UNITED STATES PATENT AND TRADEMARK OFFICE

10/607,138

Office Action Summary	Application No. 10/607,138	Applicant(s) HACK ET AL.	
	Examiner Thinh T Nguyen	Art Unit 2818

DETAILED OFFICE ACTION

FIG. 16

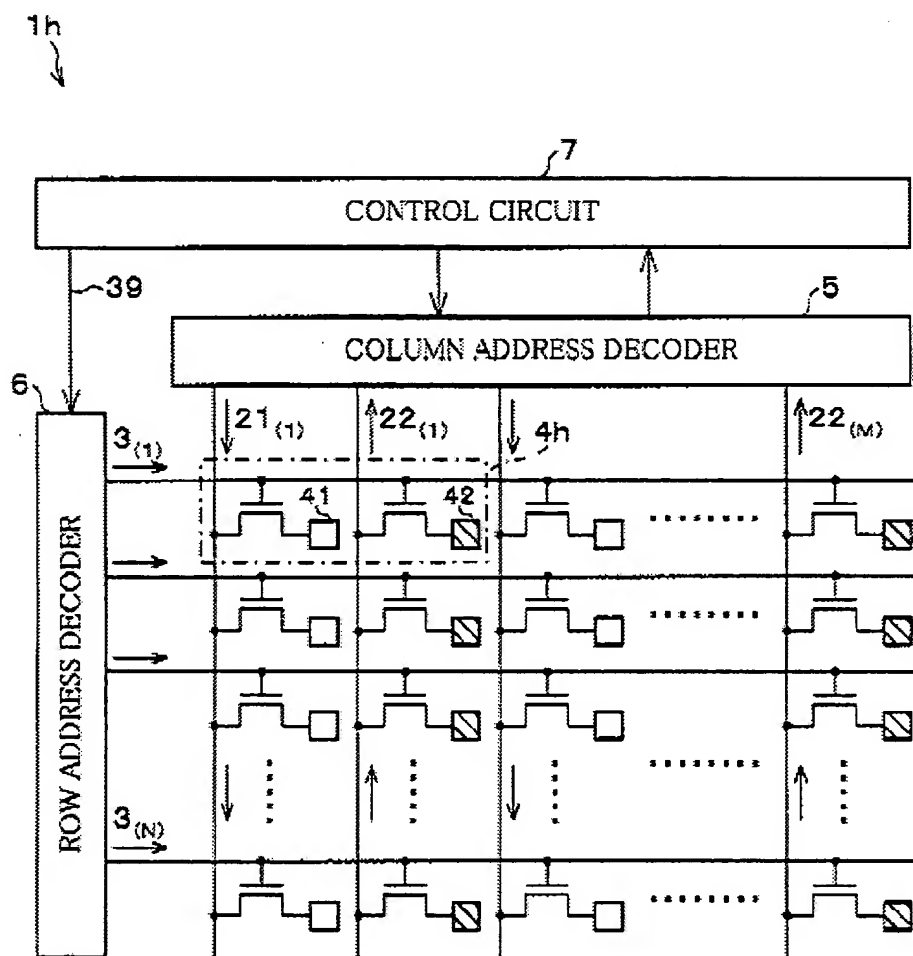
Okamoto (the abstract, fig 1,fig 16, paragraph [0091] discloses a device, comprising: a pixel having a plurality of bistable subpixels { fig 16 reference 4-1 4-2,) each subpixel having an ON state and an OFF state; a plurality of power lines (fig 1 lines Vref and Vd,) wherein a different power line is coupled to each bistable subpixel; and circuitry connected to the plurality of power lines, wherein the circuitry is capable of individually controlling a power signal
